**MOUND PLANNING COMMISSION REGULAR MEETING AGENDA
TUESDAY, APRIL 2, 2024, 7:00 P.M.
COUNCIL CHAMBERS, MOUND CENTENNIAL BUILDING
5341 MAYWOOD ROAD, MOUND, MN**

TO: Planning Commission
FROM: Rita Trapp and Natalie Strait, Consulting Planners
Sarah Smith, Community Development Director
DATE: March 28, 2024
SUBJECT: Consideration of variance request (Case No. 24-02)
APPLICANT: Paul Wolfe & Kristi Wolfe
LOCATION: 4360 Wilshire Blvd (PID No. 19-117-23-13-0014)
MEETING DATE: April 2, 2024
COMPREHENSIVE PLAN: Low Density Residential
ZONING: R-1A Single Family Residential

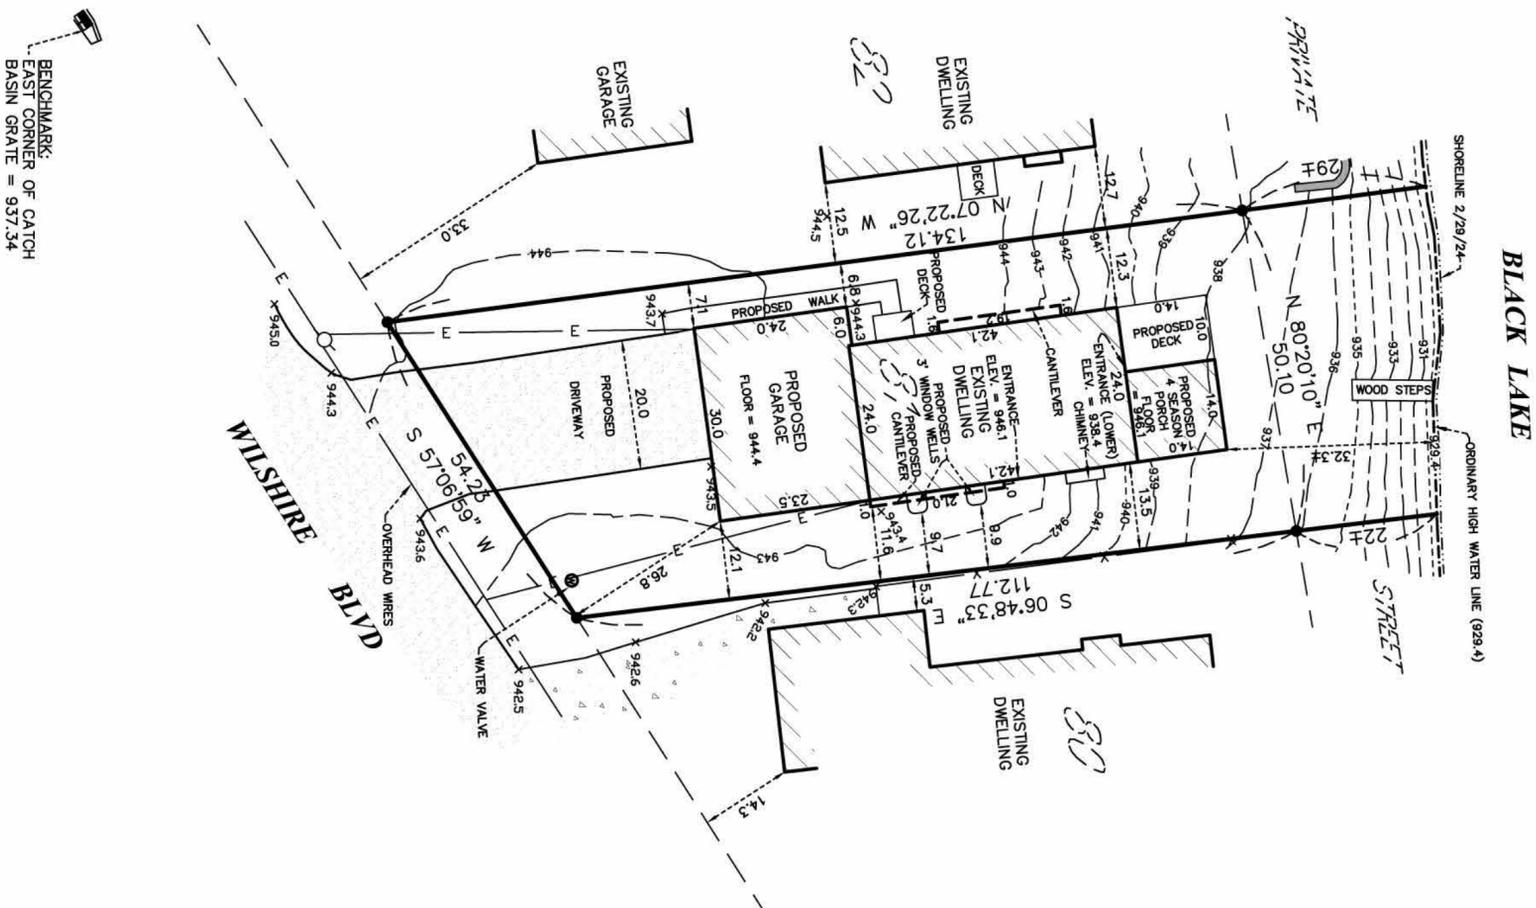
- (6) There were some errors identified in the proposed survey. The first error is that the hardcover calculations from the revised existing survey were not updated. That revised survey shows the existing hardcover on the property to be 39.4%, which is under the 40% allowance for a lot of record. Then, in the existing survey, the replacement deck was not included in the proposed hardcover calculations. The estimated area of the proposed deck is 140 square feet. If the proposed deck were to be included in the proposed hardcover calculation, the total lot coverage would equal 40.5%. The maximum allowed hard cover for R-1A lots is 40%. Also, there was a notation on the proposed survey that the cantilevers were not included and they count towards hardcover. Staff will work with the applicant to clarify what adjustments can be made to maintain the lot under the 40% maximum allowance. Members are advised that existing hardcover on the property has not been field verified.

- (1) Hardcover shall not be increased beyond 40%.
- (2) The proposed survey must be updated so that the hardcover calculation of existing matches the existing survey.
